Form 3160-5 (August 2007)

1. Type of Well					8. Well Name and No. EMPIRE ABO UNIT 005A	
☑ Oil Well ☐ Gas Well ☐ Other					<u></u>	
2. Name of Operator Contact: ISABEL HUDSON APACHE CORP E-Mail: Isabel.Hudson@apachecorp.com					9. API Well No. 30-015-00840	
3a. Address 303 VETERANS AIRPARK LA MIDLAND, TX 79705	3b. Phone No Ph: 432.81	. (include area code) 8.1142		10. Field and Pool, or Exploratory EMPIRE; ABO (22040)

Empire ABO Unit # N-5 API # 30-015-00840 Eddy County, NM

Empire Abo Unit 005A 30-015-00840 Apache Corporation December 07, 2016 Conditions of Approval

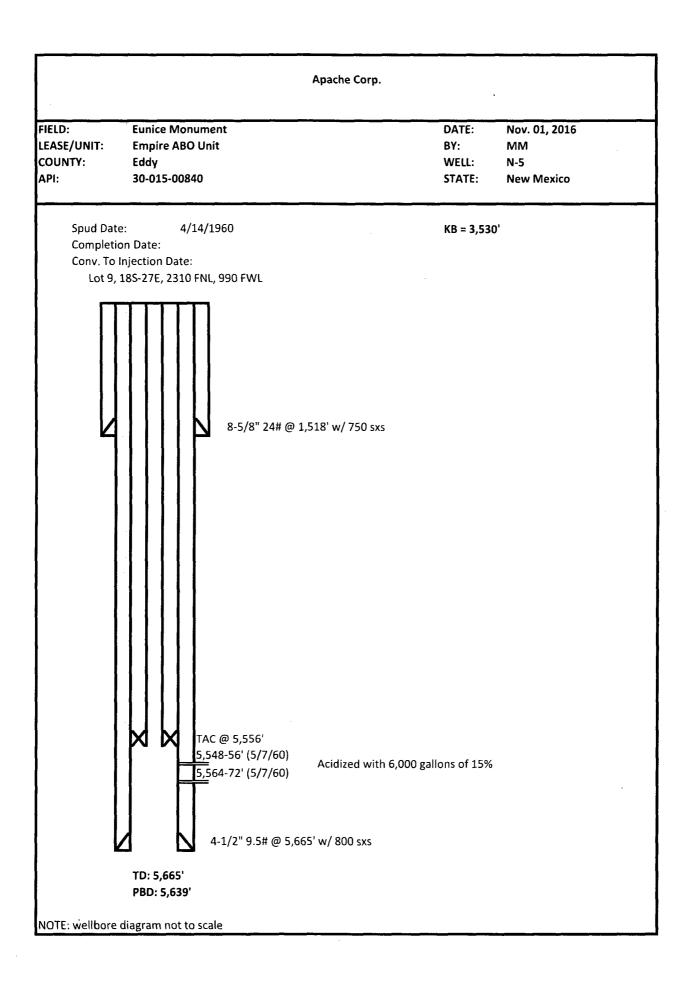
- 1. Must conduct a casing integrity test before <u>perforating and fracturing</u>. Submit results to BLM. The CIT is to be performed on the production casing to max treating pressure. Notify BLM if test fails

- 8. Subsequent sundry required detailing work done. Operator to include well bore schematic of current well condition when work is complete.
